4. TITLE AND SUBTITLE
ONPOST/OFFPOST GROUND/SURFACE WATER MONITORING PROGRAM, TASK 44, FINAL
TECHNICAL PLAN

ENVIRONMENTAL SCIENCE AND ENGINEERING
DENVER, CO8. PERFORMING ORGANIZATION
REPORT NUMBER

ROCKY MOUNTAIN ARSENAL (CO.). PMRMA
COMMERCE CITY, CO10. SPONSORING/MONITORING
AGENCY REPORT NUMBER

8.1 GROUND_WATER	8-1
8.2 SURFACE_WATER	8-4
9.0 REFERENCES	9-1
APPENDIX A--COMMENTS AND RESPONSES TO THE DRAFT FINAL TECHNICAL PLAN, NOVEMBER 1987	
APPENDIX B--TASK 44 FINAL LETTER TECHNICAL PLAN, FEBRUARY 10, 1988 AND COMMENTS AND RESPONSES TO THE DRAFT FINAL LETTER TECHNICAL PLAN, APRIL 29, 1987

APPROXIMATE AREAL
UNSATURATED ALLUVIUM

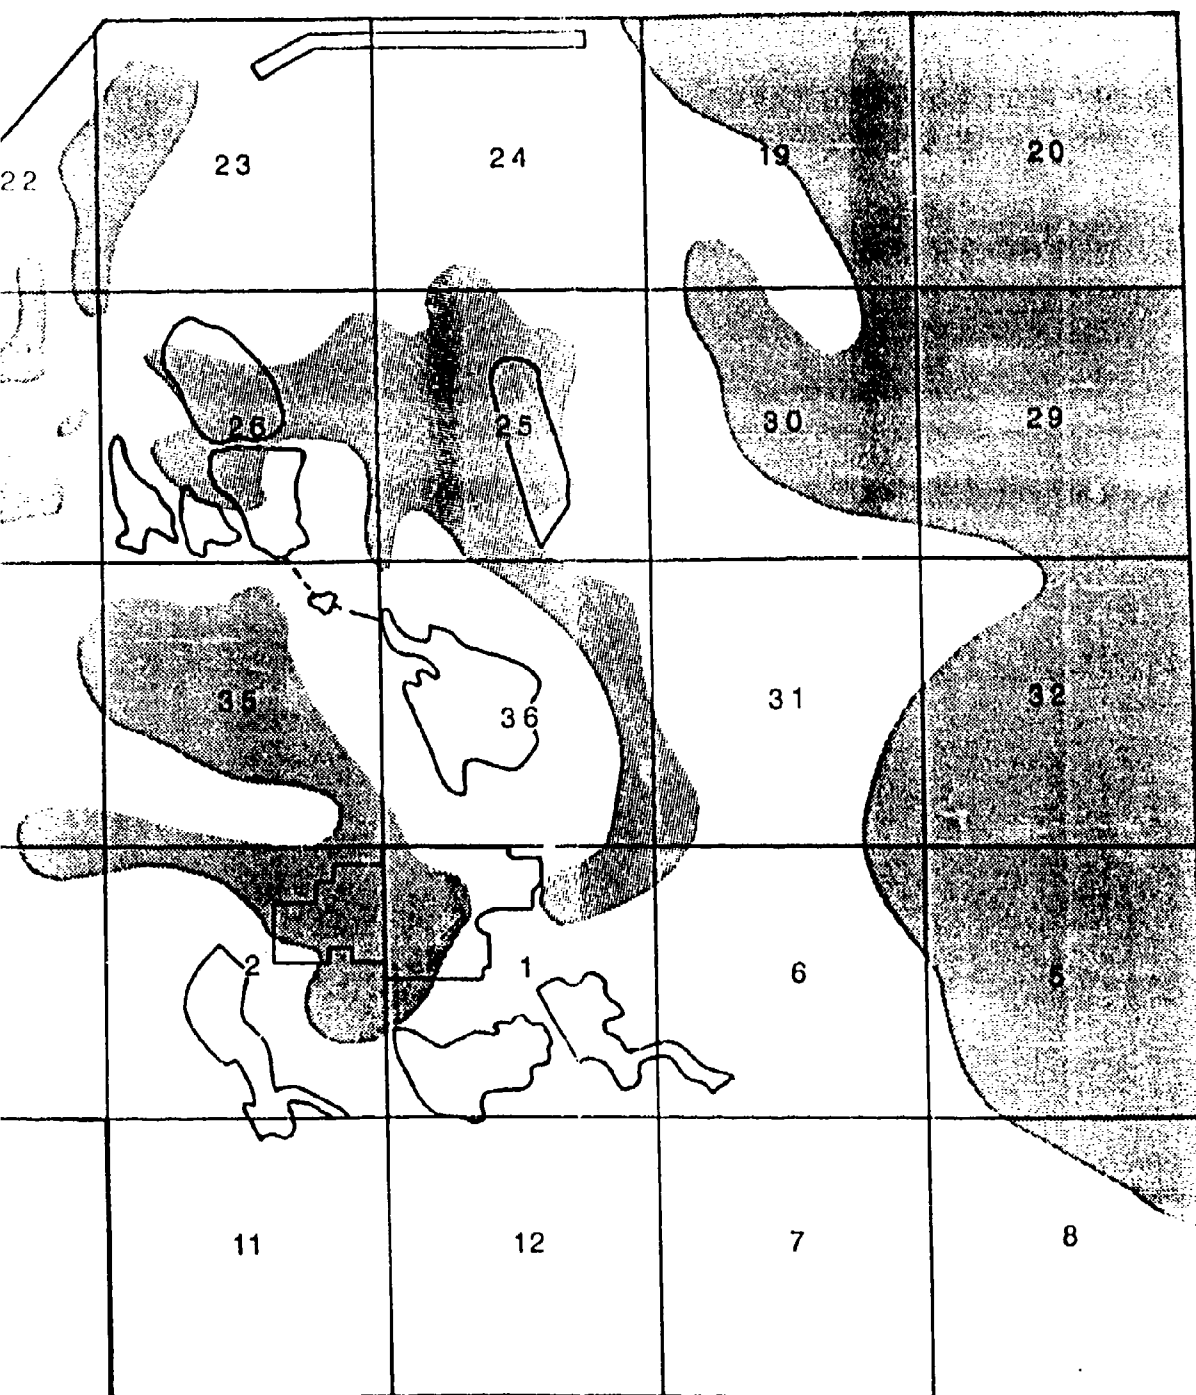
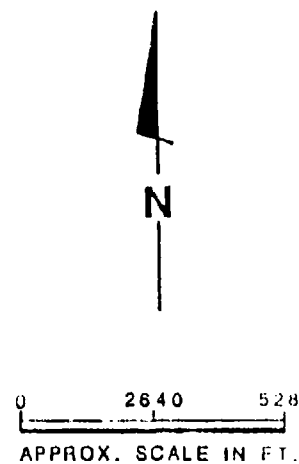
Figure 4: Does the saturated alluvium map represent a wet, dry, or average year? Both the high and low water table conditions need to be considered to insure unbiased selection of wells in areas where water level fluctuations produce periodic saturation of alluvial sediments.

The approximate areal extent of unsaturated alluvium presented in Figure 4 was constructed by modifying the unsaturated alluvium map presented in the Final Report, Selection of Contaminant Control Strategy for Rocky Mountain Arsenal (RMACCPMT, 1983). Modifications were made based on the results of the Task 4 water-quantity survey which consisted of four quarters of water-level measurement data. In general, the boundaries of unsaturated alluvium shown in Figure 4 were defined by wells periodically found to be dry during Task 4. Areas depicted as saturated contain Task 4 wells found to contain water consistently throughout the duration of Task 4. However, this map will be revised as additional data are generated and as further hydrogeologic interpretations are made.

Figure 5
PREFERRED BEDROCK PALEOCHANNELS

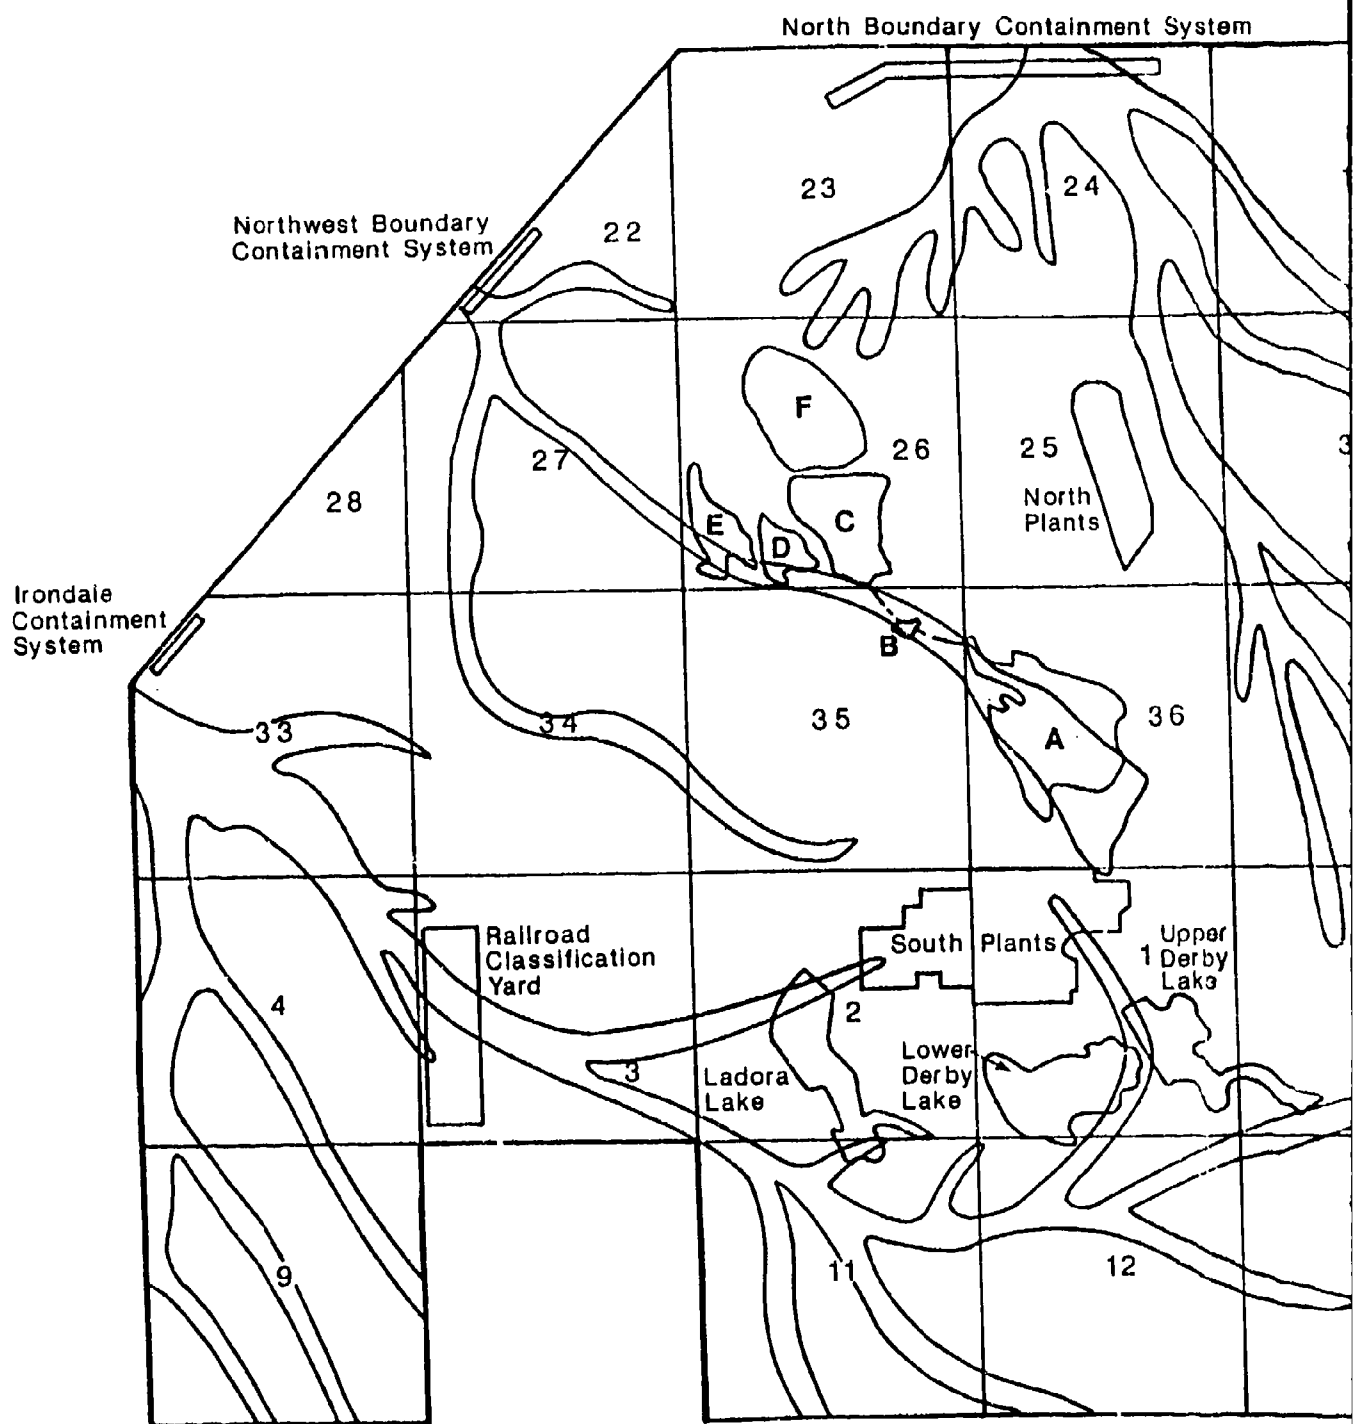
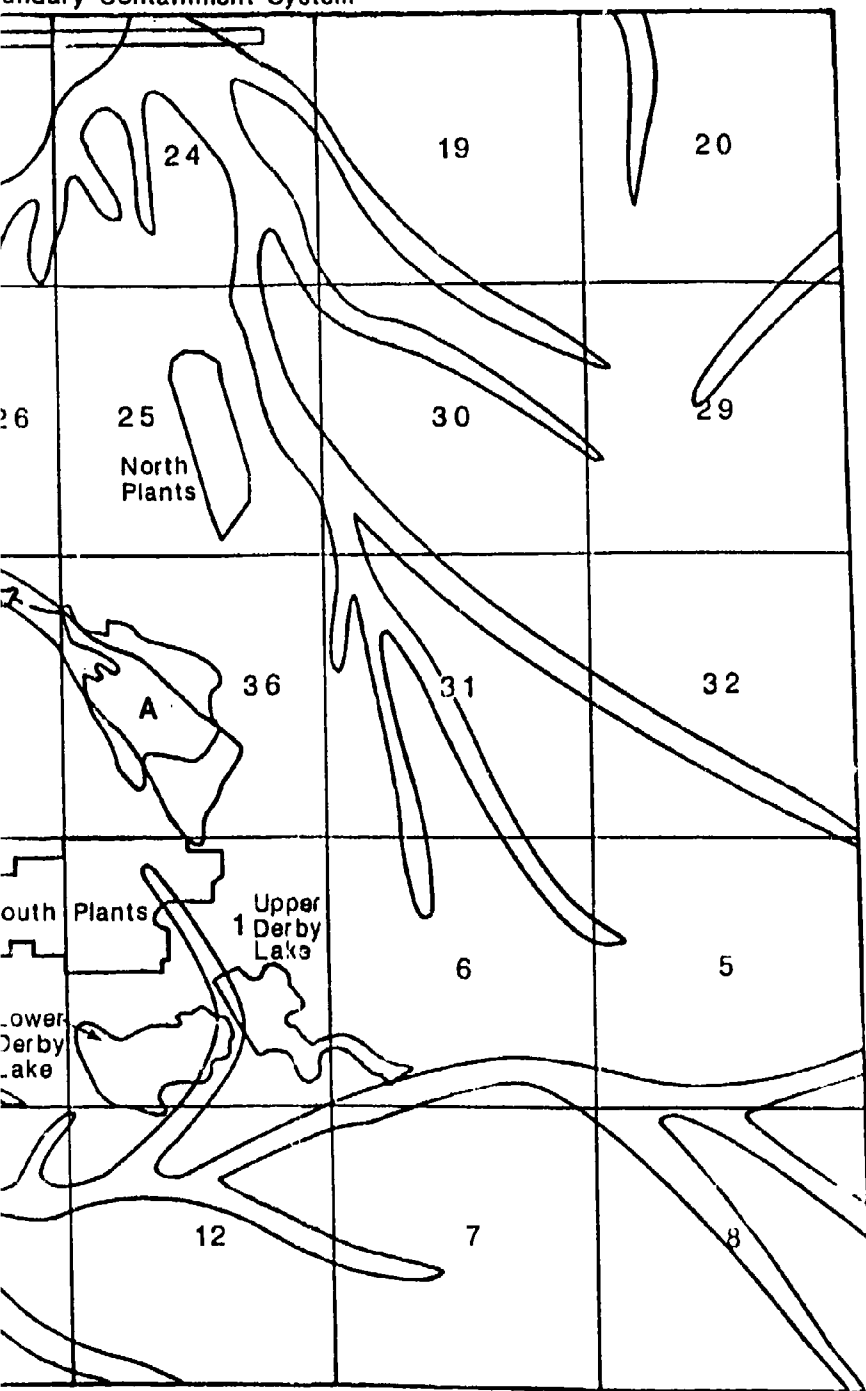
Page 11, Figure 5: The inferred bedrock paleochannel map correlates well with the MKE interpretation, with the exception of Section 34. Drilling conducted in 1986 by MKE indicates that the small channel originating in Section 35 is not continuous through Section 34. The channel picks up again in the northwest quarter of Section 34.

The locations of inferred paleochannels shown on Figure 5 were established based on available geologic and hydrogeologic information. This map will be updated and revised accordingly as Task 44 interpretations are completed. These interpretations will incorporate data generated under Tasks 25, 26, 38, 39, and 44 and Shell investigations. Please refer also to our response to CDRI Specific Comment 14.

Figure 6
DOMINANT ALLUVIAL GROUND
WATER FLOW DIRECTIONS

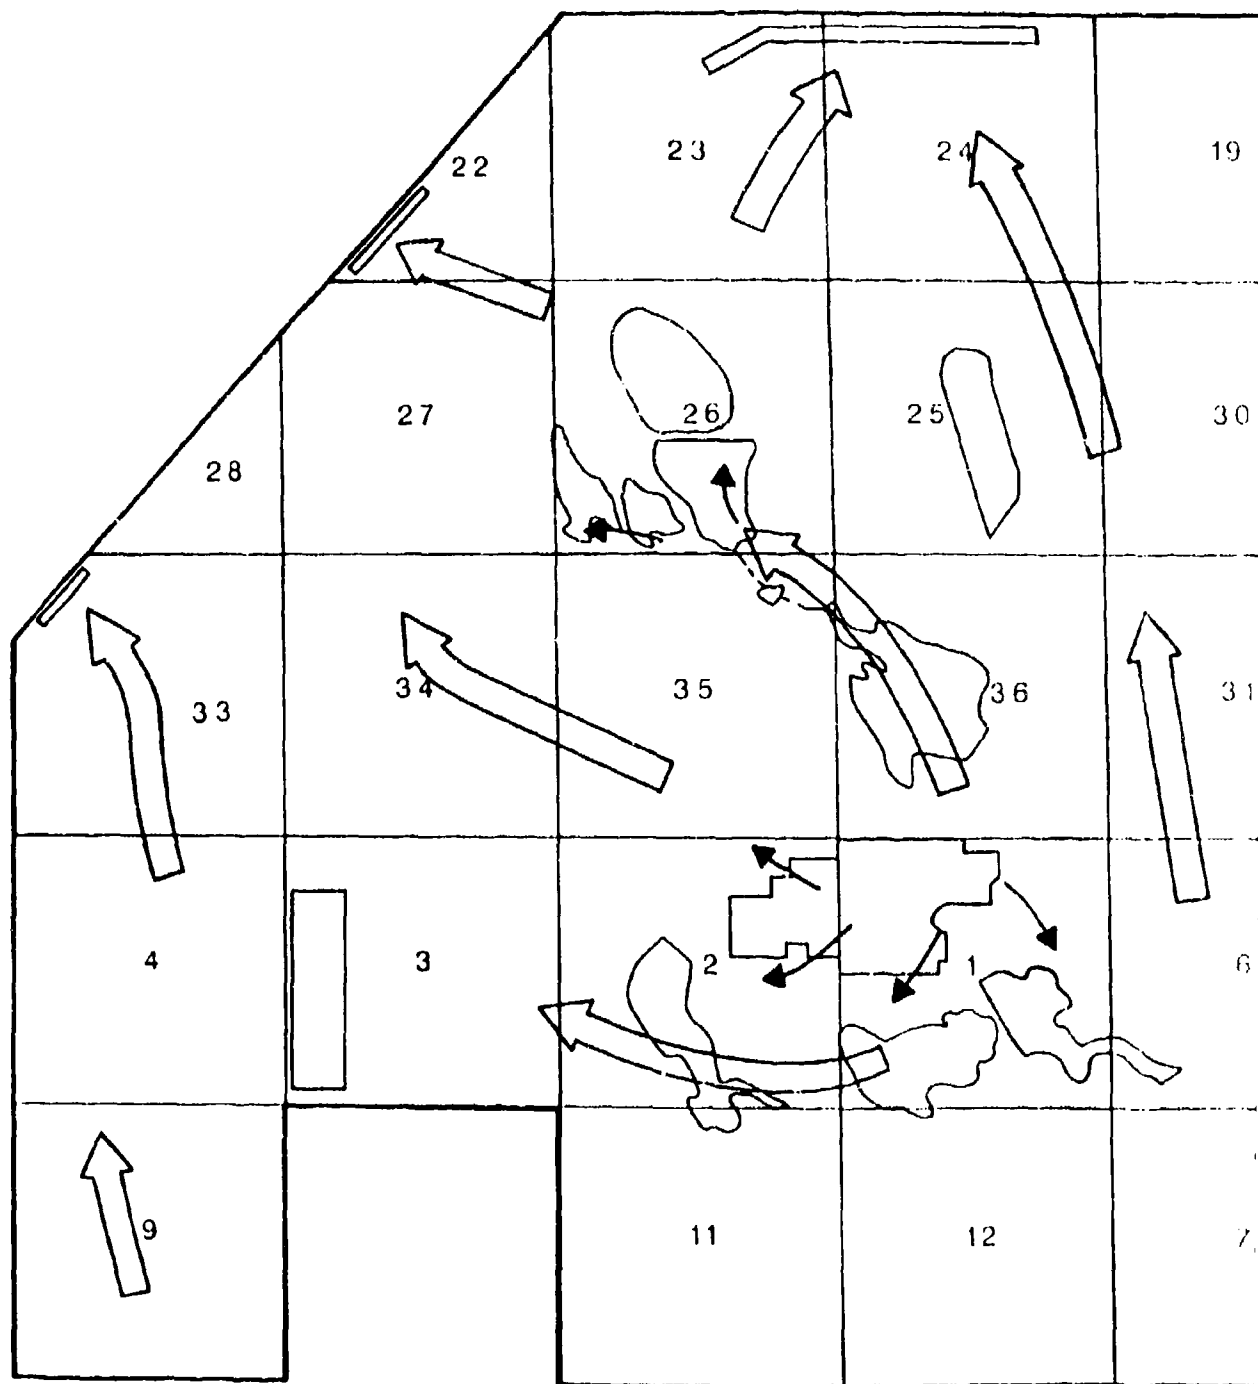
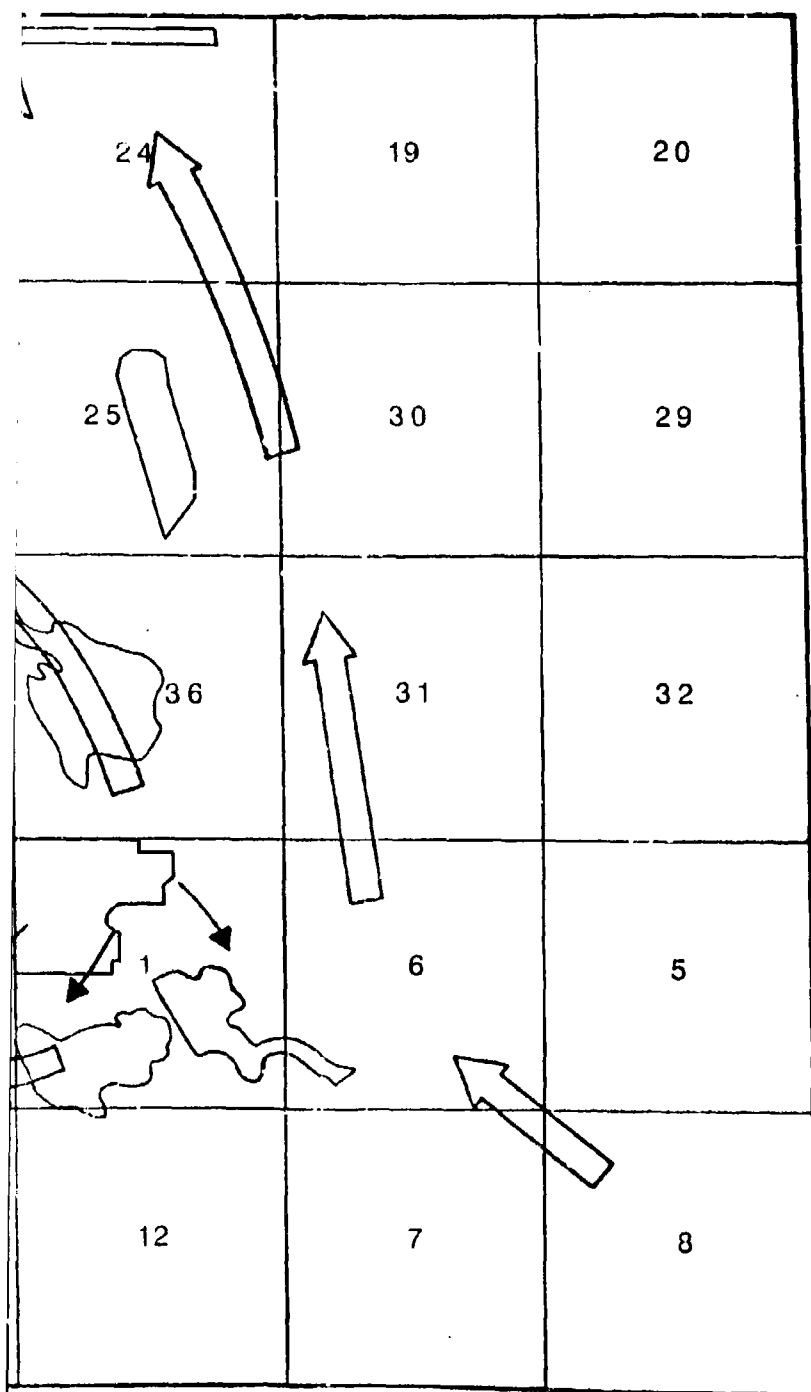
P.12 Figure 6. Regional and localized groundwater flow should not be represented using subjective arrows that appear to identify the locations of the three operating boundary systems. A potentiometric surface contour map would be more useful to demonstrate the uppermost groundwater flow directions.

The ground-water flow directions presented in Figure 6 were drawn based on previous hydrogeologic investigations (May 1982) and on recent water-table contour maps (Task 4). A map showing ground-water flow directions and water-table contours will be presented in the Task 44 Technical Plan.

Ground-water flow directions shown on Figure 6 are based on the results of previous RMA hydrogeologic studies (May 1982) and recent (Task 4) water table contour maps. Flow directions were not drawn with inference to any previously identified contaminant distributions. Therefore, it would be inappropriate to depict the movement of DBCP contamination from the Rail Classification Yard to the Irondale Containment System as a localized ground-water flow direction in Figure 6.
